Referee 1

Many thanks for your detailed review and your feedback. All our responses or comments are written in green through the text.

Piel et al. describe the development of a cavity enhanced spectrometer for the simultaneous measurement of dioxygen concentration and its oxygen-18 isotopic composition. The instrument performances are excellent, reaching detection limits of 0.002 % for O₂ concentration and 0.06 ‰ for $\delta^{18}\text{O}(\text{O}_2)$ in 20 minutes. This development is of significant interest to the scientific community, with multiple environmental applications. However, although the manuscript is highly relevant to AMT's readership and overall well-written, it needs major improvement before being considered for publication.

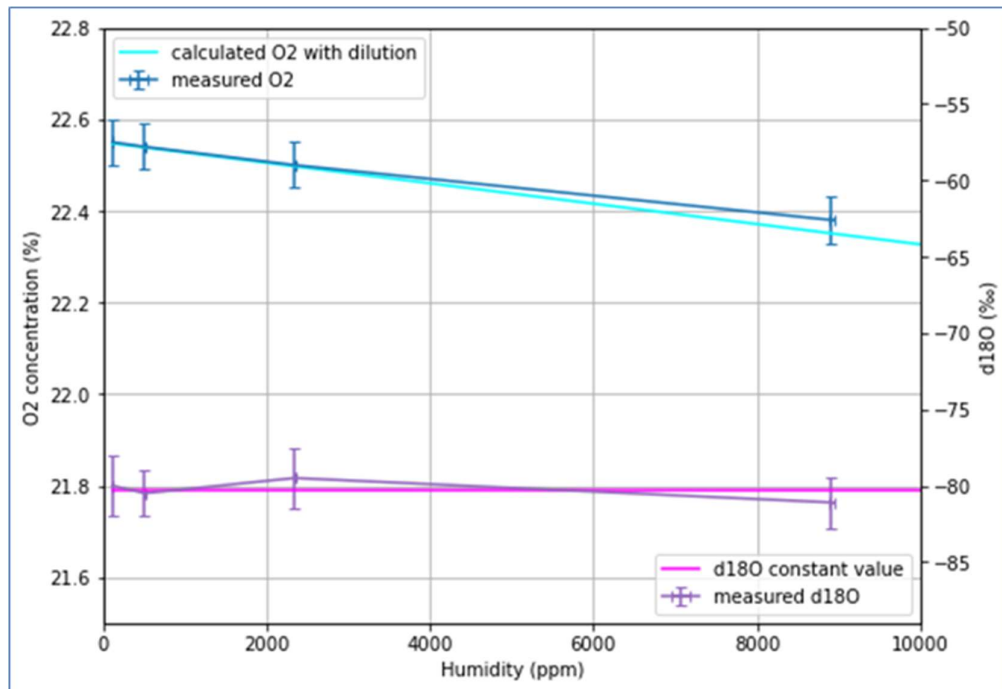
- Line 293: Data should be provided to support this statement. Because we remove the water, we only characterize with a few data points the dependency of d₁₈O and O₂ on humidity. The graph is provided below and can be included in the revised version of the manuscript if needed. The dependence of the O₂ concentration is only due to the dilution of the O₂ signal by the added water vapor quantity.
